UNITED STATES PATENT AND TRADEMARK OFFICE

APPLICATION NO.	FILING DATE	FIRST NAMED INVENTOR	ATTORNEY DOCKET NO.	CONFIRMATION NO.
10/766,302	01/27/2004	Ares J. Rosakis	14850-002001	9346
20985	7590	02/24/2006	EXAMINER	
FISH & RICHARDSON, PC P.O. BOX 1022 MINNEAPOLIS, MN 55440-1022			TURNER, SAMUEL A	
			ART UNIT	PAPER NUMBER
			2877

Office Action Summary	Application No. 10/766,302	Applicant(s) ROSAKIS ET AL.	
	Examiner Samuel A. Turner	Art Unit 2877

DETAILED ACTION

FIG_1

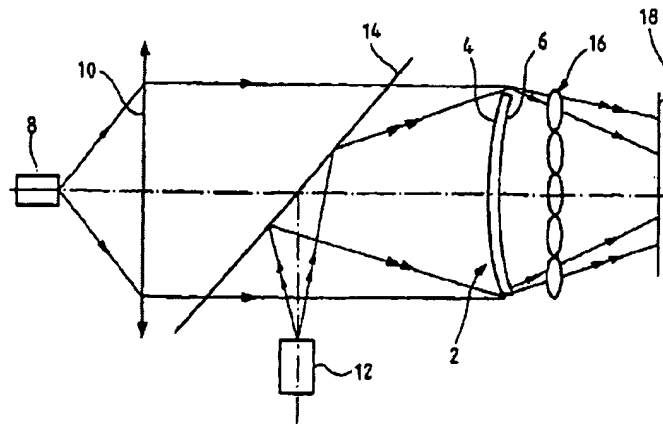
Claims 8, 9, 13, 14, 16-18 are rejected under 35 U.S.C. 102(b) as being clearly anticipated by Devie et al(WO 02/16902). See U.S. 6,909,498 for an English translation.

With regard to claim 8, Devie et al teach a method, comprising:

directing an optical reflection off a sample plate into a first optical shearing interferometer to obtain a first map of wavefront slopes of the optical reflection indicative of the reflective surface of the sample plate(page 6);

directing an optical transmission through the sample plate into a second optical shearing interferometer to obtain a second map of wavefront slopes of the optical transmission wavefront indicative of the variations in the optical path across the sample plate(page 6); and

processing the first and second maps to obtain information on the sample plate(page 6).

As to claim 9, further comprising adjusting incident angle of input probe light to the sample plate(page 6). Such that the light beam is along the axis of the component.

As to claim 13, further comprising: directing optical reflection off a second reflective surface of the sample plate into a third optical shearing interferometer to obtain a third map of wavefront slopes of the optical reflection indicative of the second reflective surface of the sample plate, wherein the processing further includes processing the third map(page 6).

As to claim 14, wherein the information to be obtained on the sample plate includes at least one of a surface flatness, surface wedge, surface slope, and surface topology of the sample plate(page 6, page 14).

With regard to claim 16, Devie et al teach a method, comprising:

directing an optical probe beam with a uniform wavefront to transmit through a sample plate(8,12; page 6);

using an optical shearing interferometer to receive optical transmission of the input probe beam through the sample plate to produce an optical shearing interference pattern(page 5); and

processing the optical shearing interference pattern to obtain a wavefront gradient map of the optical transmission(pages 6 to 7).

As to claim 17, further comprising processing the wavefront gradient to obtain a wedge slope map of the thickness of the sample plate(page 6).

As to claim 18, further comprising processing the wavefront gradient to obtain a slope map of a refractive index of the sample plate(page 14).

Fig. 1. New interferometer, consisting of two Ronchi phase gratings in series.

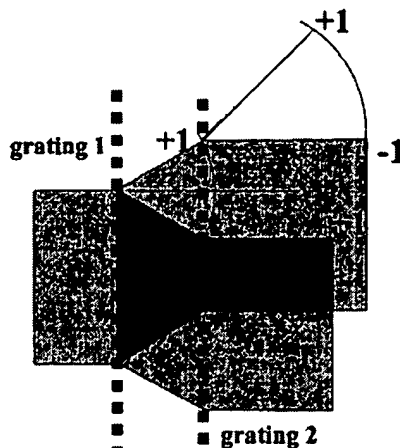
Devie et al fail to teach a specific lateral shearing interferometer.

However, Schreiber et al teach a two grating interferometer, an CGS device, wherein both the lateral and the axial movement of one grating is adjusted with respect to the other grating (page 5323, section 3).

With regard to claims 2-4, 10, 12, 19, and 20, Devie et al fails to teach specifically wherein the first and the second optical shearing interferometers are coherent gradient sensing (CGS) devices.

It would have been obvious to one of ordinary skill in the art at the time the invention was made to use any known shearing interferometer, including the two grating lateral shearing interferometer of Schreiber since the Schreiber grating allows both phase control and phase scanning (section 3).

FIG. 1

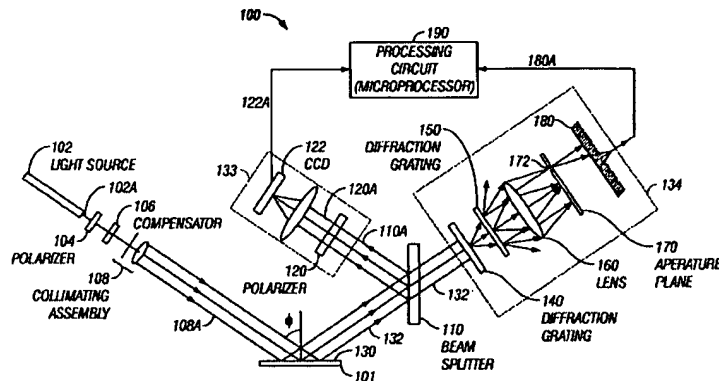
Claim 15 is rejected under 35 U.S.C. 103(a) as being unpatentable over Devie et al(WO 02/16902) as applied to claims 1, 6, and 7 above, and further in view of Boyd et al(6,469,788).

With regard to claim 15, Devie et al fail to teach any polarization control. However, Boyd et al teach placing a polarizer 104 between the source 102 and the lateral shearing interferometer 134.

It would have been obvious to one of ordinary skill in the art at the time the invention was made modify the Devie apparatus by placing a polarizer between the source and the lateral shearing interferometer in order to control the polarization of the incident light beam to provide ellipsometry measurements as found in Boyd.
